TECHNICAL BULLETIN

[Issue No.] T05-0005

[Title] Leakage Current at CC-Link Compact Remote Output

Module OFF, and Measures on Load Side

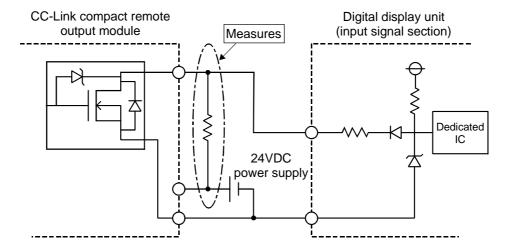
(1) When an LED is connected as the load, the LED could dimly light (dark lighting) when the output module is OFF.

Example) Izumi Denki push-button with LED: ALFN22211DNR

Measures: Connect a 5 to $50k\Omega$ resistor in parallel with the load LED.
